**CREEKSIDE SOUTH AT LORSON RANCH  
PUD Preliminary Landscape Plan**

**CREEKSIDE SOUTH AT  
LORSON RANCH**  
 El Paso County, Colorado  
**PUD & PRELIMINARY PLAN**

**LANDSCAPE  
COVER  
SHEET**  
**LS1** 11 OF 14

# LS v\_7 redlines.pdf Markup Summary 8-27-2020

**PLANT SCHEDULE:**

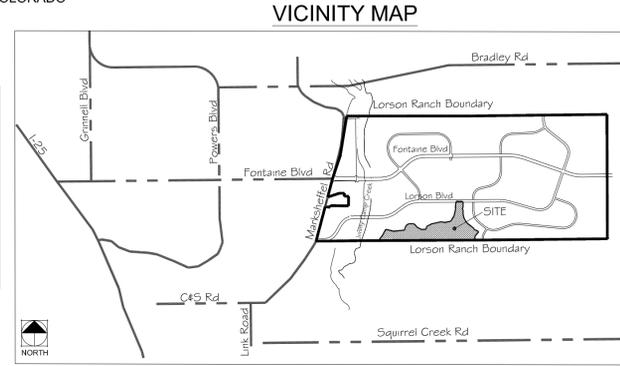
Counts are the same as pre-BOCC

forgot to add the additional buffer trees

forgot to add the additional buffer trees

Counts are the same as pre-BOCC
